Attachment A – List of Affected FSAR Sections

Attachment B - SGTR Figures

Attachment C - FSAR Addendum Markups

FIGURE 16.5-33H

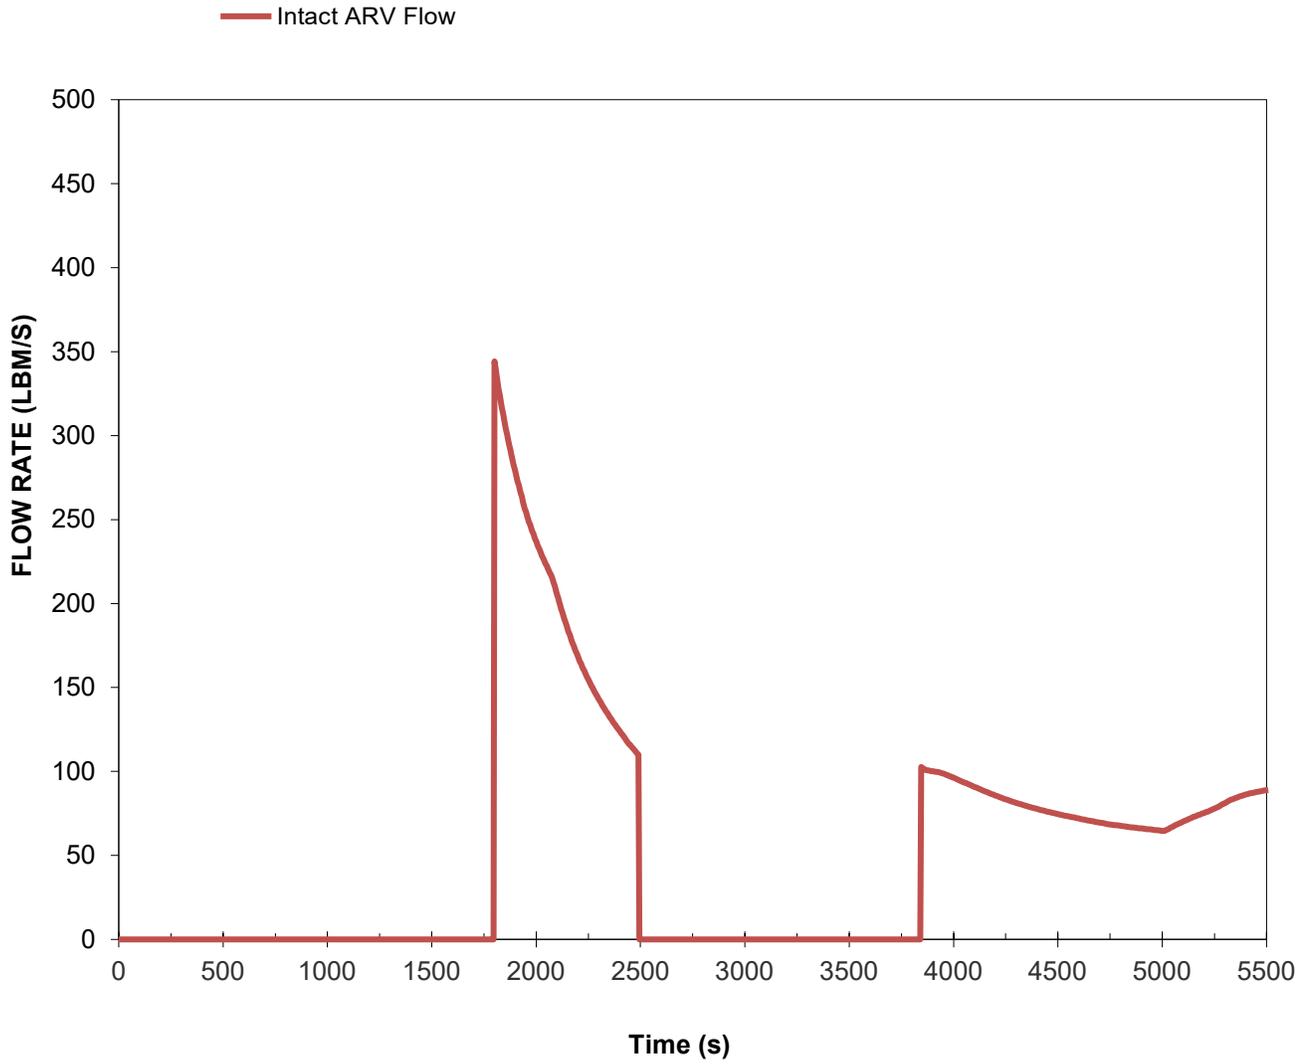
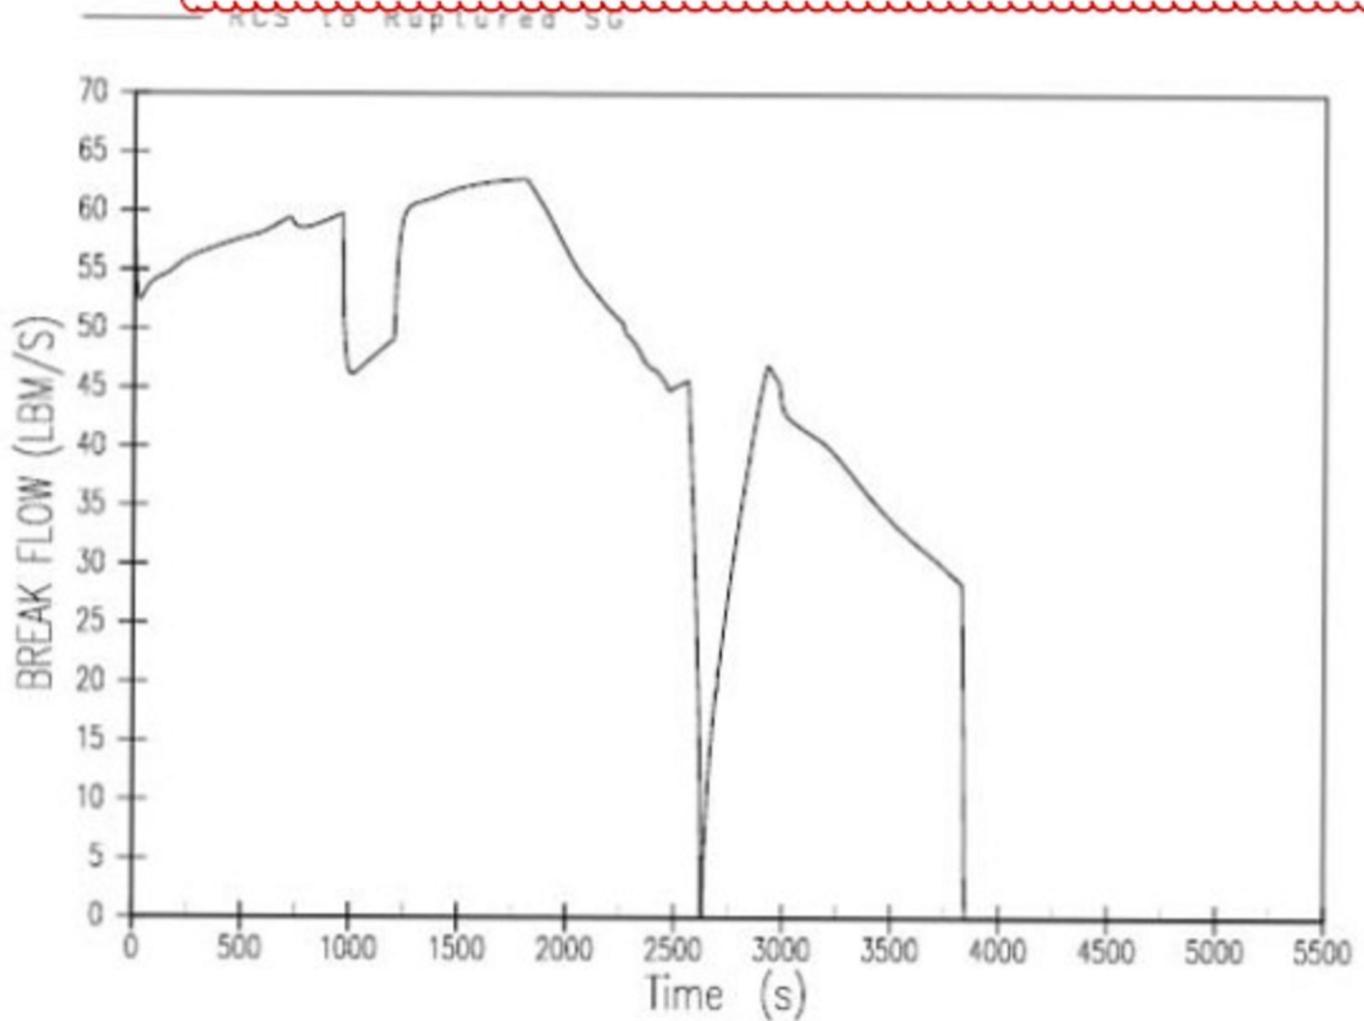
k. The intact SG releases are modeled using the RETRAN analysis results presented in Figure 15.6-33h. ~~In the calculation of doses for the cooldown to RHR conditions it is assumed that 1.25E6 lbm of steam is released from the intact SGs from the time of break flow termination. This value was conservatively calculated for the case with the failed open ASD presented in Section 15.6.3.1.3 and remains conservative when applied to the analysis of the SGTR with overfill.~~

Replace with graph on Tab I (Indigo) from spreadsheet "Overfill_FSAR_Plots.xlsx"

Figure 15.6-33h: Replaced with Tab H in spreadsheet "Overfill_FSAR_Plots.xlsx"

FIGURE 15.6-331

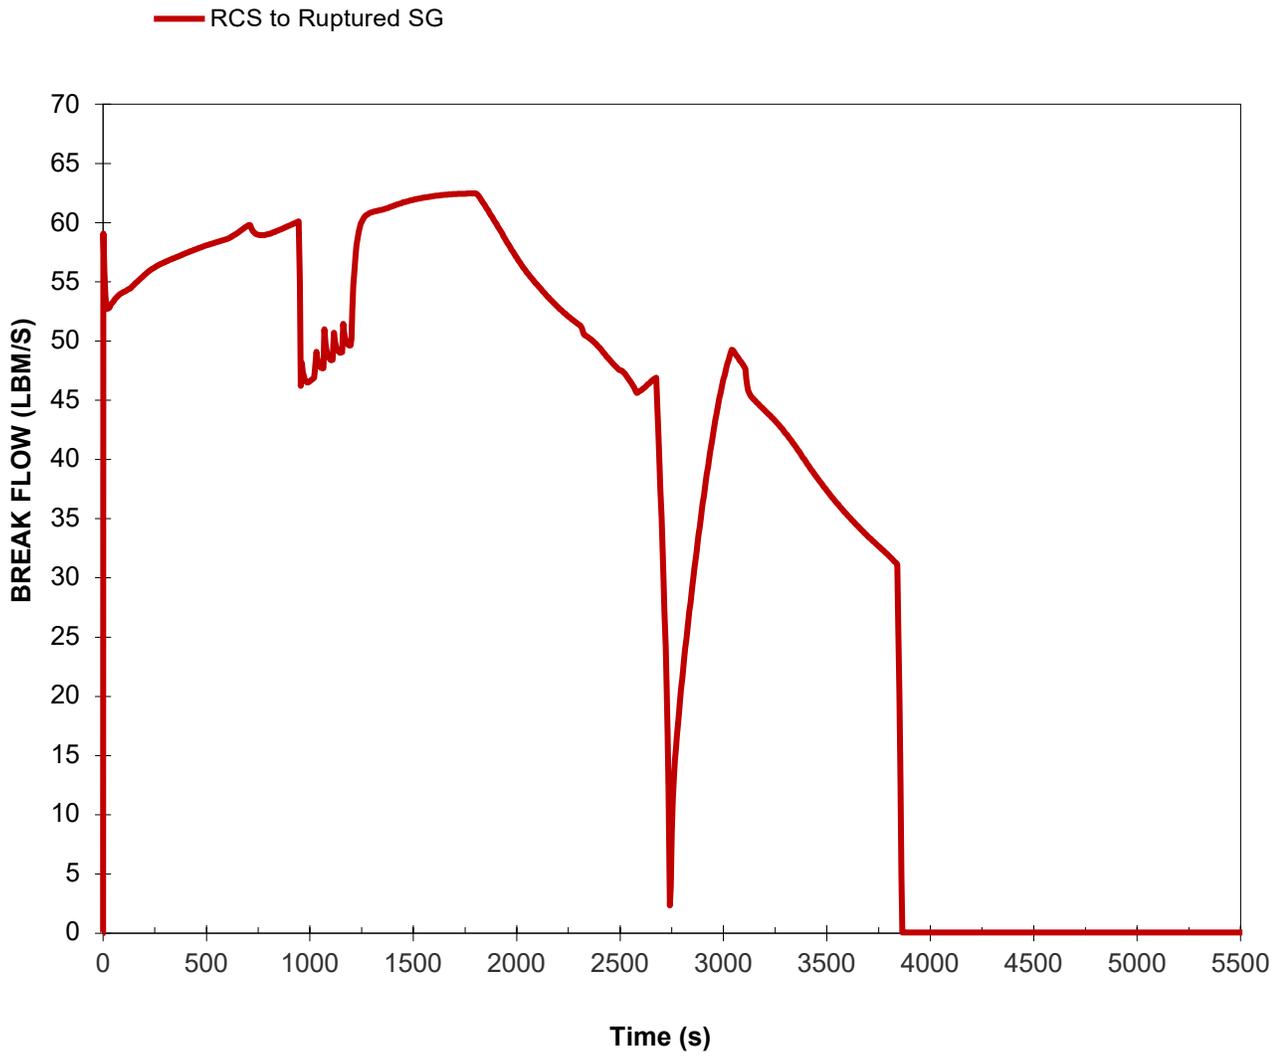
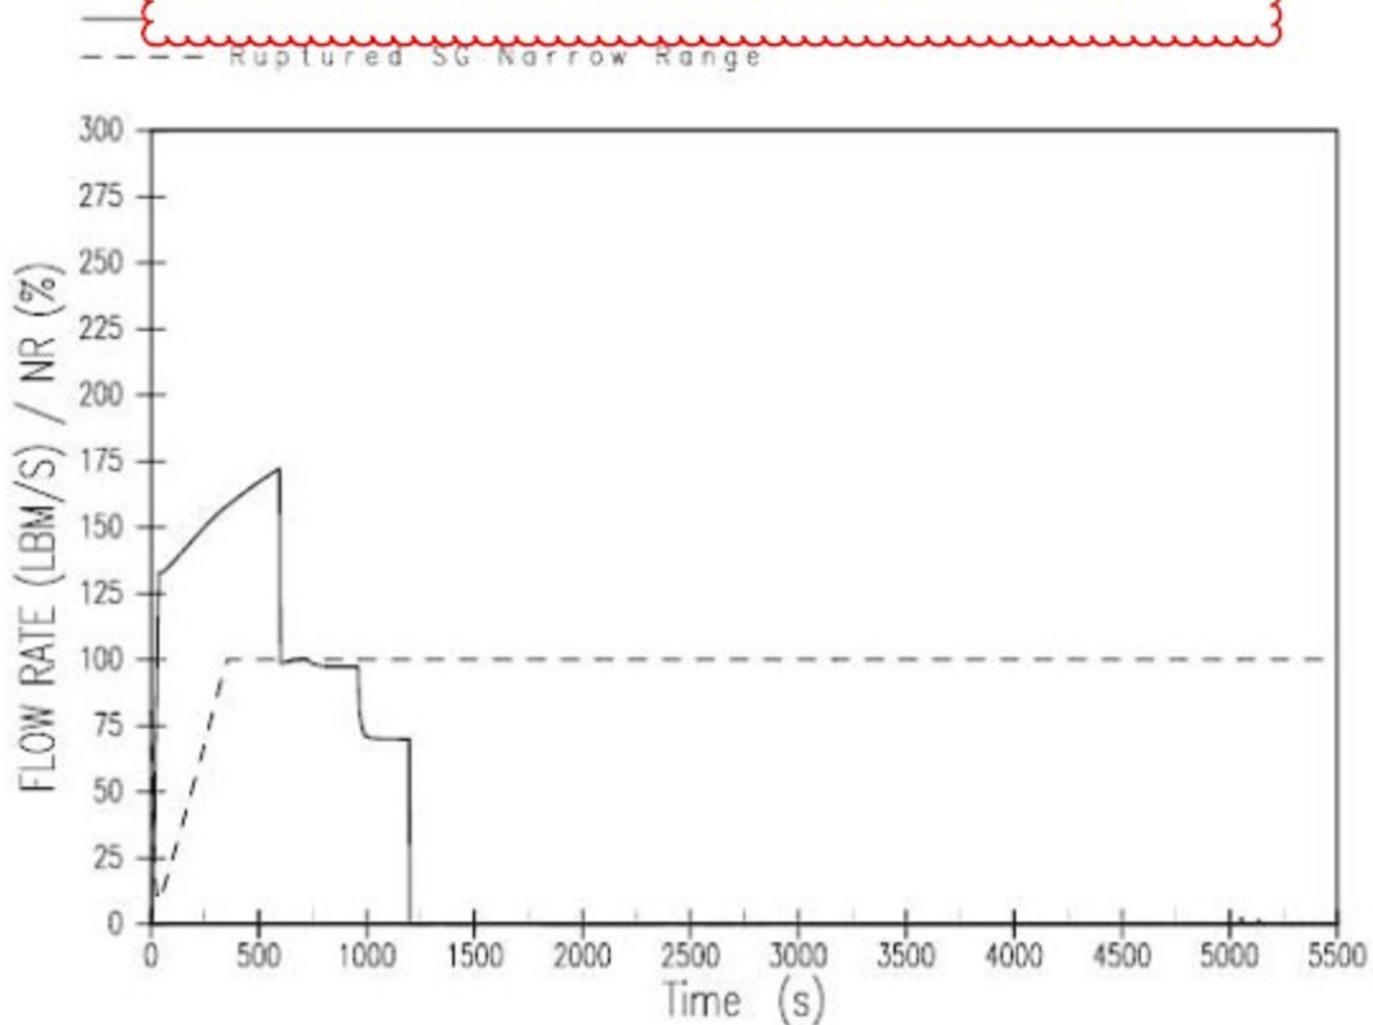
- ~~The Section 15.6.3.1.3 dose analysis conservatively modeled a constant break flow rate. For the analysis of doses for the overfill case the transient break flow rate from the RETRAN analysis presented in Figure 15.6-33i is used, up until the time when water relief stops. This is consistent with the analysis approved in Reference 3.~~
- ~~The calculation of iodine doses until RHR conditions are reached conservatively assumes a break flow of 4 lbm/sec until 5 hours after break flow termination. This is consistent with the analysis approved in Reference 3. This portion of the analysis assumes that RHR conditions are achieved within 5 hours of break flow termination, even though the intact SG releases and the noble gas releases assume 8 hours.~~

Replace with graph on Tab J from spreadsheet "Overfill_FSAR_Plots.xlsx"

Figure 15.6-33i: Replaced with Tab I in spreadsheet "Overfill_FSAR_Plots.xlsx"

FIGURE 16.6-33J

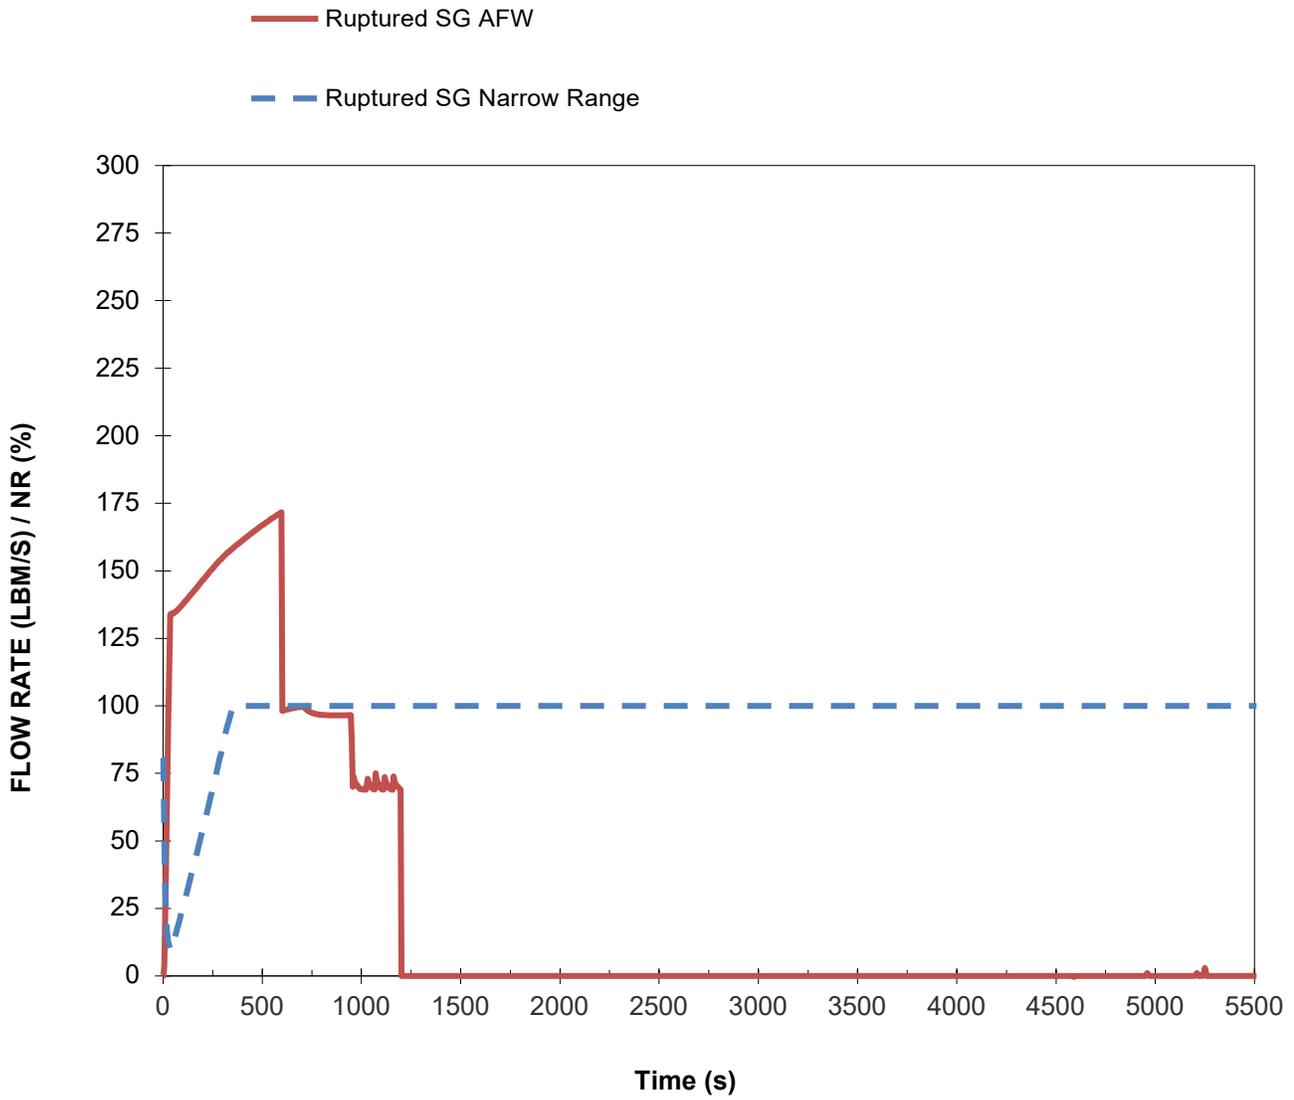
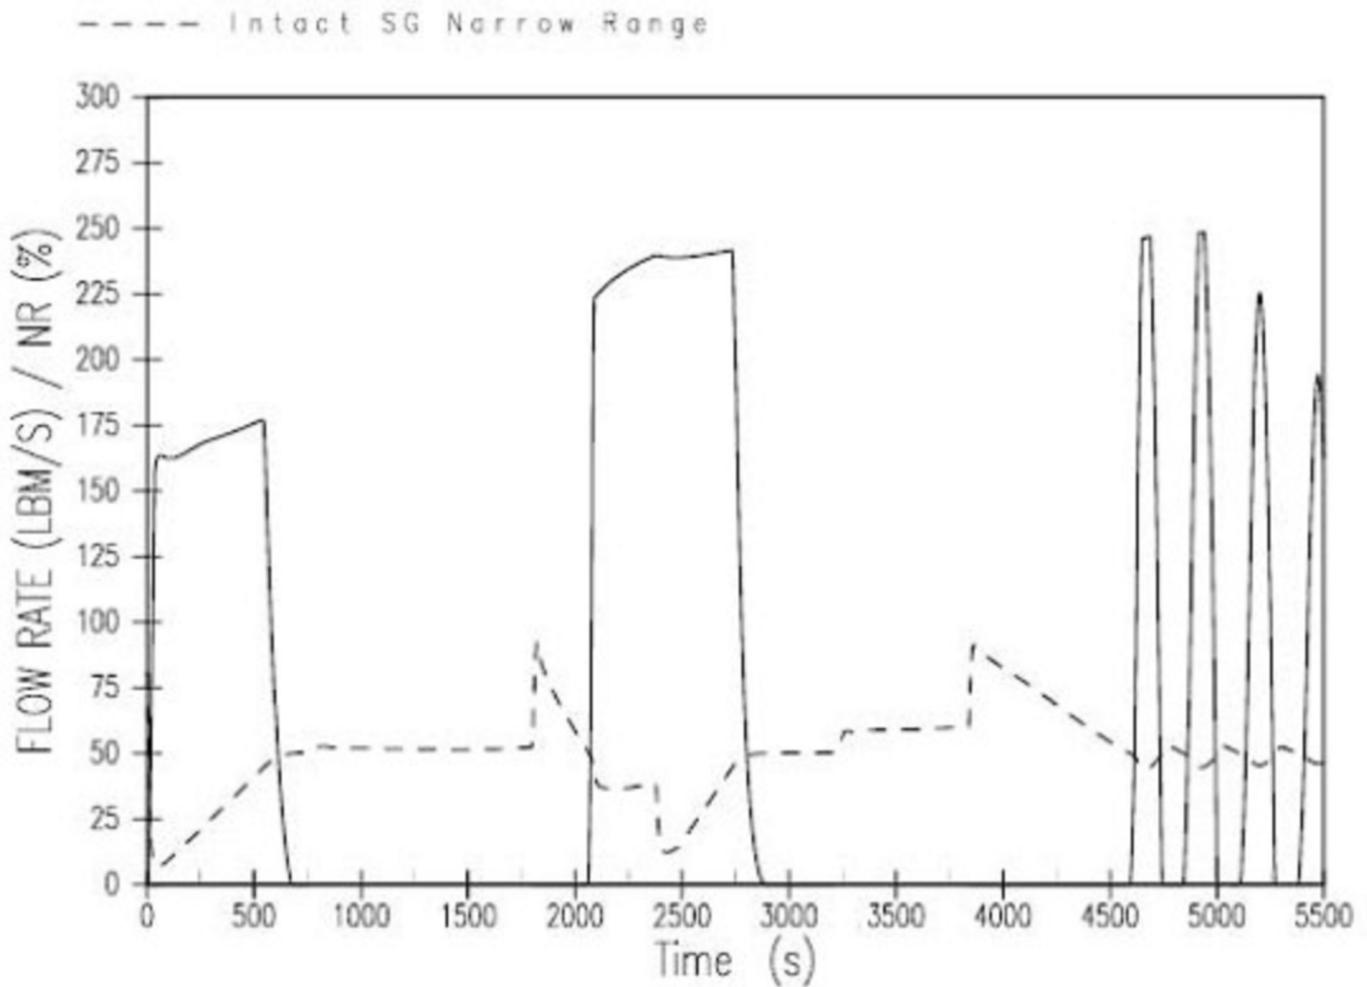
and secondary side water level in Figure 15.6-33j are used. Figure 15.6-33j shows that the tube bundle in the ruptured SG effectively remains covered for the duration of the accident. On this basis, credit is taken for scrubbing of the flashed fraction

Replace with graph on Tab K from spreadsheet "Overfill_FSAR_Plots.xlsx"

Figure 15.6-33j: Replaced with Tab J in spreadsheet "Overfill_FSAR_Plots.xlsx"
